Subject: Greensward Road Type III Variance Request

This letter is provided in response to comments received during the meeting on December 4, 2018 and subsequent communication regarding the Type III variance request from the City of Columbus Stormwater Drainage Manual (SWDM) for the proposed Greensward Road residential development. This response to comments is being submitted on behalf of Romanelli & Hughes Building Company.

CITY OF COLUMBUS, FRANKLIN COUNTY, OHIO
 SCPZ VARIANCE FOR
GREENSWARD ROAD
 PREFERRED OPTION

CITY OF COLUMBUS, FRANKLIN COUNTY, OHIO
 SCPZ VARIANCE
GREENSWARD ROAD
 MITIGATION PLAN

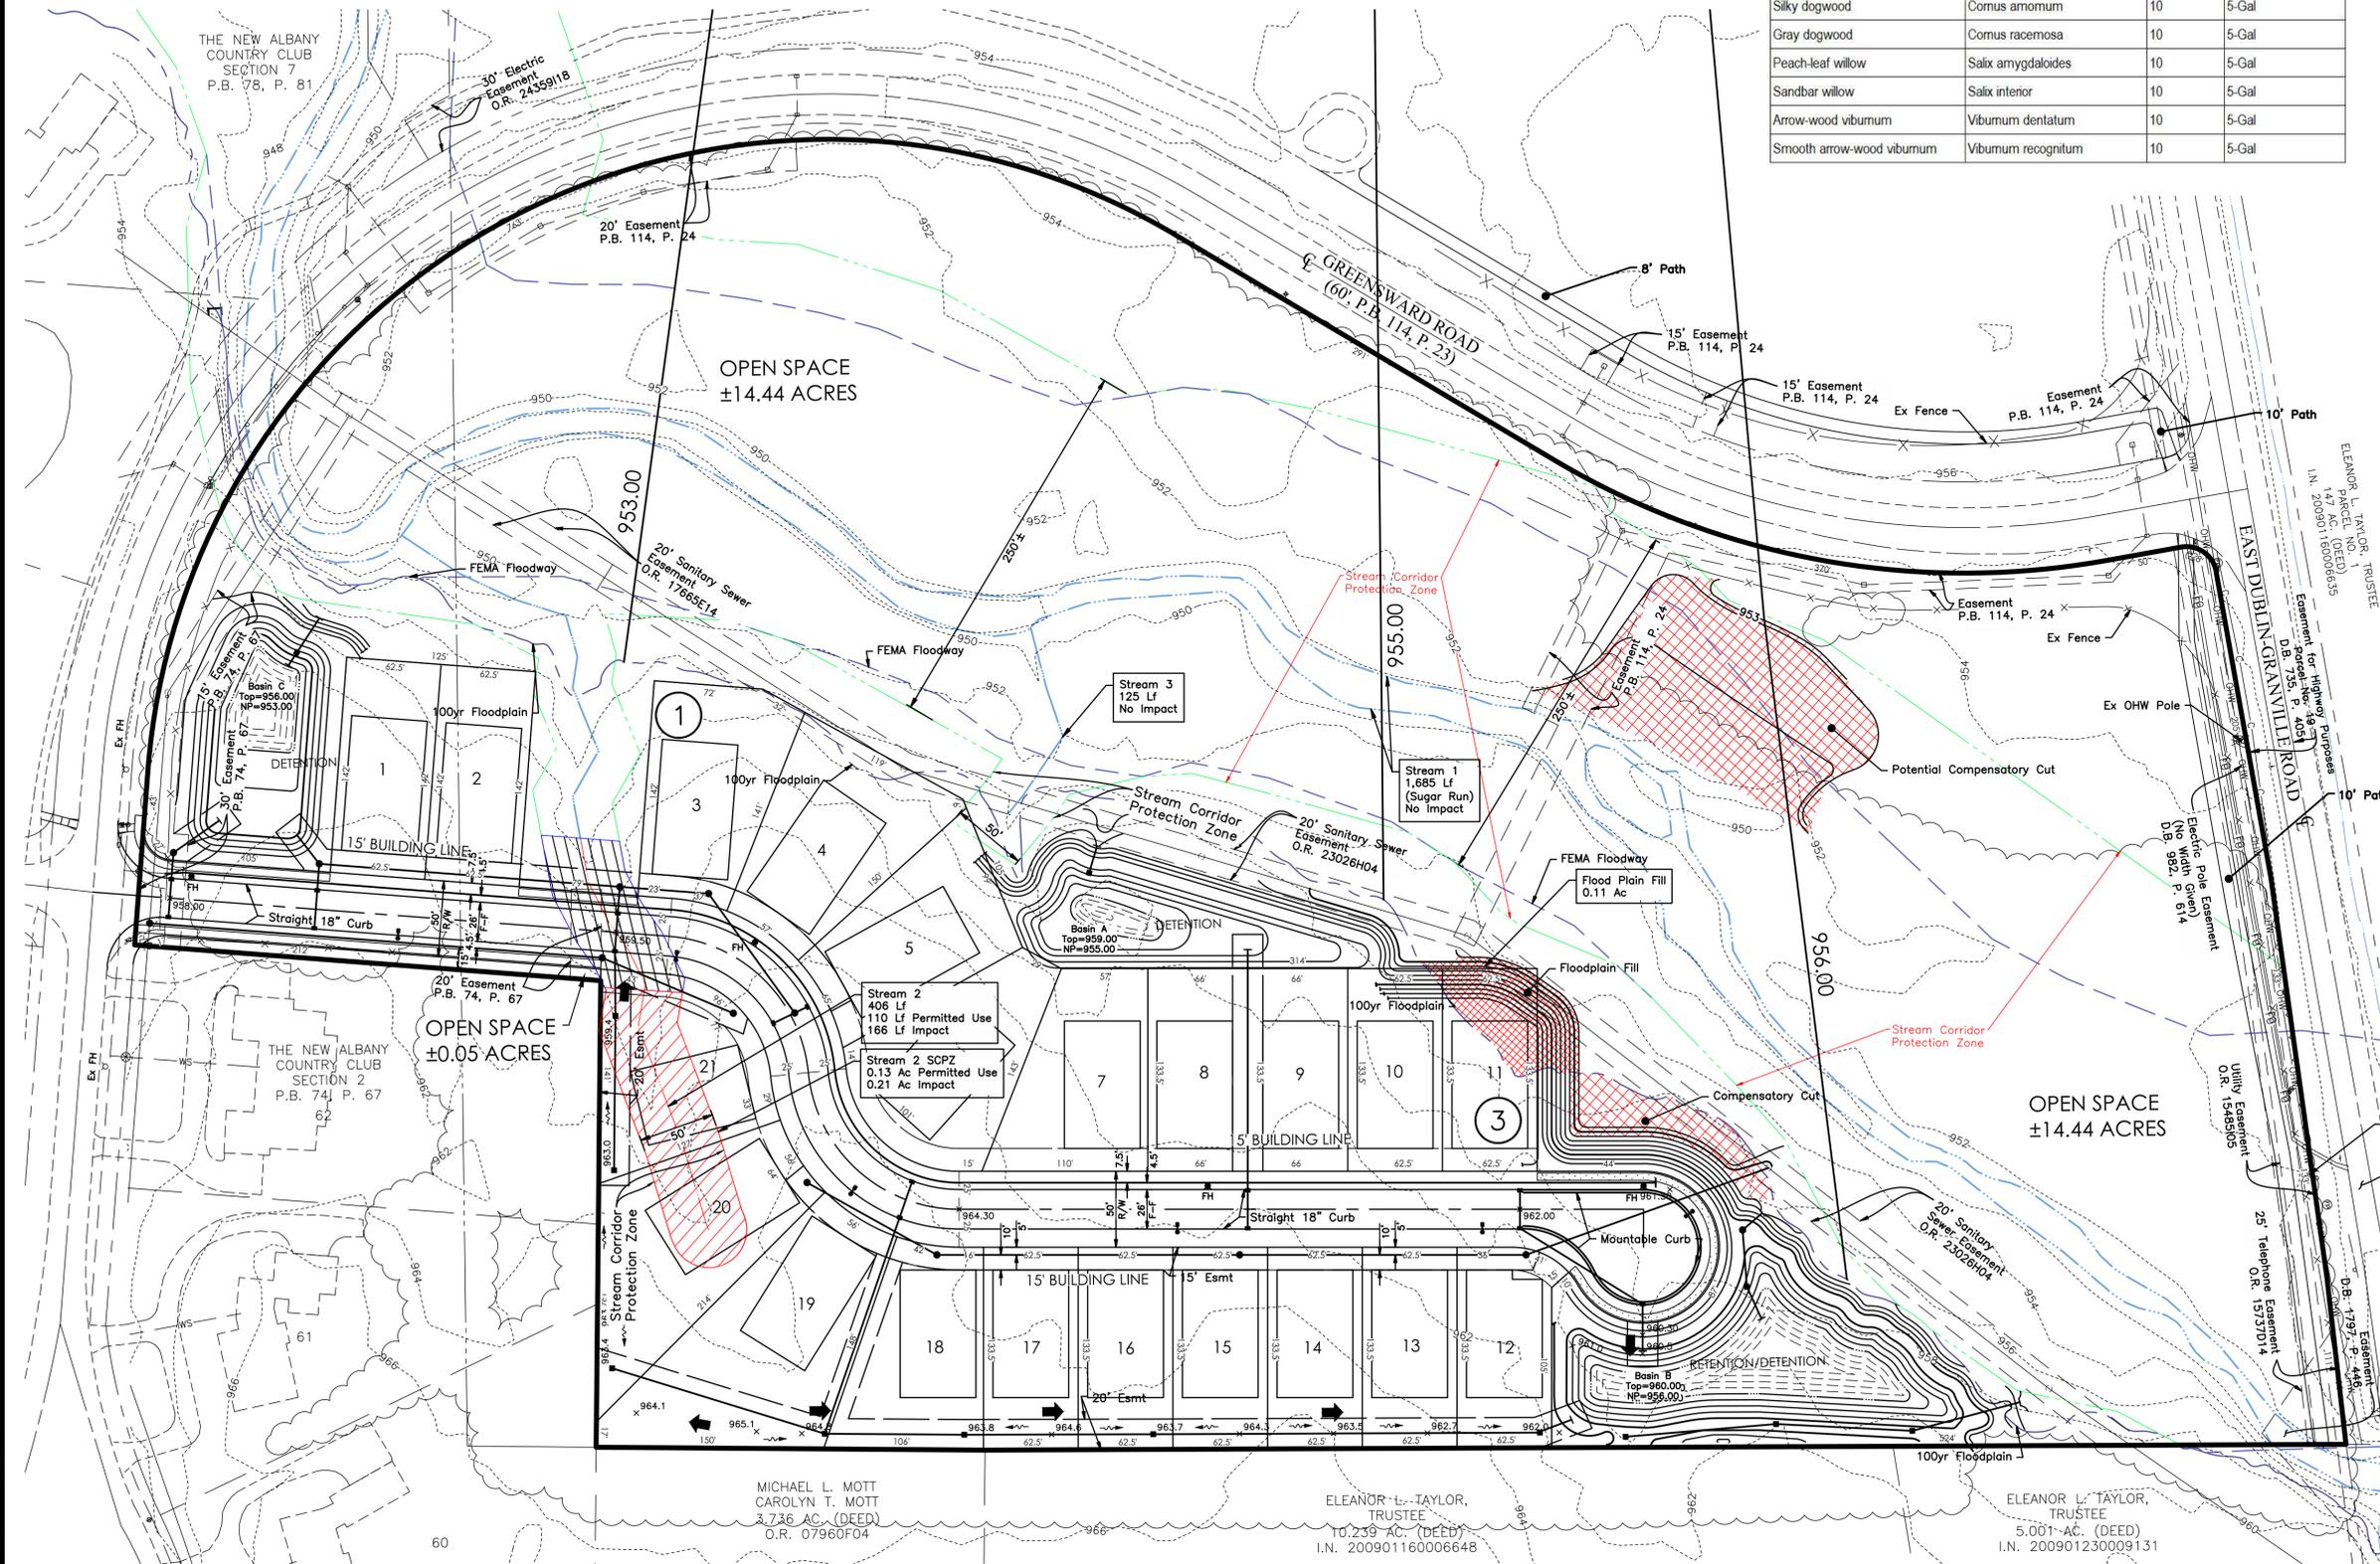
The City has indicated that additional information is necessary regarding how full compliance with the manual deprives Romanelli & Hughes of reasonable use of land and/or results in a substantial hardship. The following information is submitted for the Variance Committee's consideration:

Since submittal of the variance request on September 28, 2018, the preferred development plan has been modified. The revised preferred plan is attached. Modifications were made in part to reflect further refinement of the preliminary design, and in part to address the City's request to minimize direct stream impacts and SCPZ encroachment and provide additional water quality benefits. The revised plan is still preliminary, and subject to change based on detailed design.

As shown on the revised plan, "non-permitted" impacts to Stream 2 have been reduced to 166 linear feet of direct stream impact and 0.21 acre of SCPZ. Impacts to the Stream 3 SCPZ have been eliminated. The overall impacts have been reduced by approximately 50% as compared to the impacts requested under the previous preferred plan (318 linear feet of direct channel impacts and 0.43 acre of SCPZ). Minimization of the impacts to Stream 2 result in the loss of one (1) housing lot as compared to the plan previous submitted.

In order to avoid the loss of an additional housing lot, Basin C (north of Greensward Road) has been modified. In addition to changing the geometry of this basin, the applicant intends to implement this basin as a wetland basin to be planted with native shrubs and herbaceous plants. Planting the basin will provide greater water quality and habitat benefits as compared to a standard dry-bottom basin by filtering pollutants and providing wildlife habitat. This improvement will help to offset the potential water quality impact associated with the impact to Stream 2 in addition to the extensive mitigation proposal (discussed below).

EMH&T has evaluated the City's suggestions to further reduce/eliminate the stream and SCPZ impacts and has determined that it is not feasible to further reduce the impacts while maintaining at least 21 lots. The site is constrained not only by the onsite SCPZ areas, but also by the floodplain and existing sanitary sewer easement. Provision of fewer than 21 lots on the site reduces the project return to the point that the project becomes financially unviable.
